# Access Compliance Report

## Public Rights-of-Way

### (Curb Ramps)

Intersection ID: 29414	Main Street: LINDA_LAKE_DR	Cross Street: POSSUM_TROT_LN	Location: S
ADA ID: D7A3996D0A51	Ramp Type: BlendTrans1	Initial Pass/Fail: Fail	Overall Compliance: No
		Severity Score: 8.75

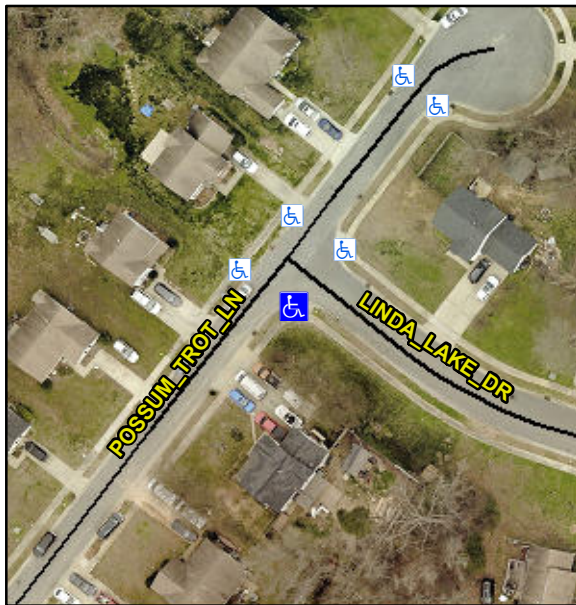
**Not Found, R304.5.1**

Compliance	Description	Data	Compliance	Description	Data
N/A	Ramp Length (in)	44.0	Yes	BlendTrans Slope (%)	3.1
No	Ramp Width (in)	47.5	Yes	BlendTrans XSlope (%)	1.5
N/A	Flare Type LT	N/A	N/A	Flare Type RT	N/A
N/A	Flare Slope LT (%)	N/A	N/A	Flare Slope RT (%)	N/A
N/A	Flare Traversable LT?	N/A	N/A	Flare Traversable RT?	N/A
N/A	Landing Length (in)	N/A	N/A	DWS Provided?	N/A
N/A	Landing Width (in)	N/A	N/A	DWS Contrast?	N/A
N/A	Landing Slope (%)	N/A	N/A	DWS Length (in)	N/A
N/A	Landing X Slope (%)	N/A	N/A	DWS Full Width?	N/A
N/A	Landing Curb? (Y/N)	N/A	N/A	DWS Offset (in)	N/A
N/A	Shared Landing?	N/A			
N/A	Gutter Ponding?	N/A	N/A	Gutter Slope (%)	N/A
N/A	Gutter Lip Ht (in)	N/A	N/A	Gutter X Slope (%)	N/A
N/A	Painted X Walk1?	No	N/A	Painted X Walk2?	No
	X Walk 1 Direction	To NE		X Walk 2 Direction	To NW
	X Walk 1 Width (in)	N/A		X Walk 2 Width (in)	N/A
	X Walk 1 Slope (%)	1.5		X Walk 2 Slope (%)	2.2
	X Walk 1 X Slope (%)	0.2		X Walk 2 X Slope (%)	0.7

N/A	Ramp inside XWalk1?	N/A	N/A	Ramp inside XWalk2?	N/A
	Road Slope (%)	0.6		Clear Space?	N/A
	Road X Slope (%)	5.1	N/A	Clear Space to XWalk (in)	N/A
N/A	Any Obstructions?	N/A	N/A	Storm Grate/Utility Hazard?	N/A
	Obstruction Type			Storm Grate/Utility Type	
		N/A			N/A
			Yes	Surface Condition? (G/P)	Good
			No	Curb Slope (%)	7.4

**Remove & Replace Curb Ramp With Two New Directional Ramps or Equivalent.**
